Technical Bulletin

Number:	MTFW-16-99
Date:	12-8-99
Model:	645 XL and Plus
Subject:	Lifter Release Spring and Assembly

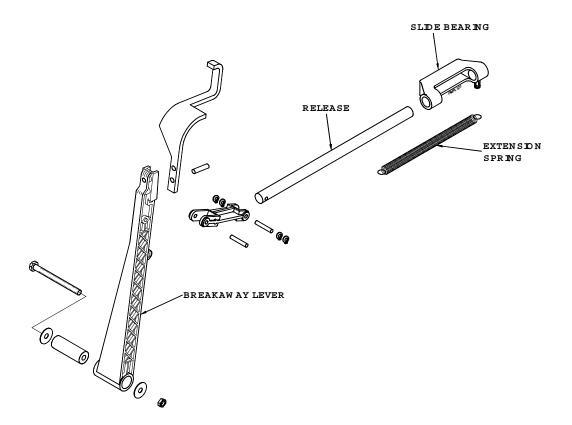
The tension on the lifter release extension spring has been reduced to limit early fatigue of the breakaway lever (PN 82755500A), slide bearing (PN 82755500A) and/or extension spring (PN 82755600A). When replacing the breakaway lever or slide bearing, also replace the extension spring with the new extension spring PN A82755600A.

The release rod (XL PN A82838900A or Plus PN A82755400A) has been modified to eliminate a press fit and now uses a longer pin held in place with four grip rings. The old rod can be modified by drilling the hole larger with a #21 drill (.159). When replacing or modifying the release rod also order one (1) 4mm by 30mm long dowel pin (PN 83058000A) and four (4) 4mm grip rings (PN 83058100A).

Part Description	Old Part Number	New Part Number
Extension Spring	82755600A	A82755600A
Release Rod - Plus	82755400A	A82755400A
Release Rod - XL	82838900A	A82838900A
